Parking Structure 3 EFIS Repairs

ADDENDUM #2

Addendum No. 02

Parking Structure 3 EIFS Repairs
UK #CCK-2968.1

1
PANEL FLASHING
DETAIL
501 3" = 1'-0"

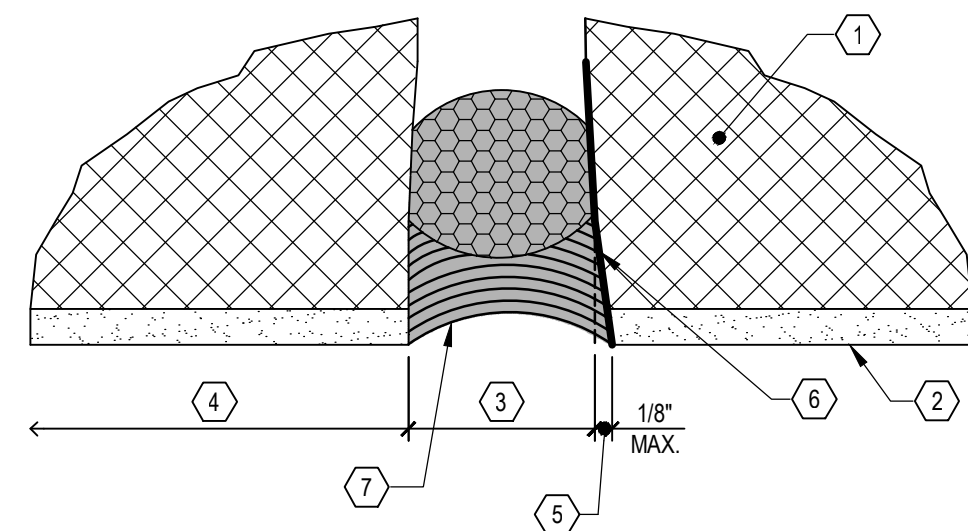
1. Replace Sheet 501:
 - a. Detail 1 updated to clarify location of sealant and membrane turn-up.
2. Replace Sheet 701:
 - a. Detail 4 updated to show top of through-wall scupper.
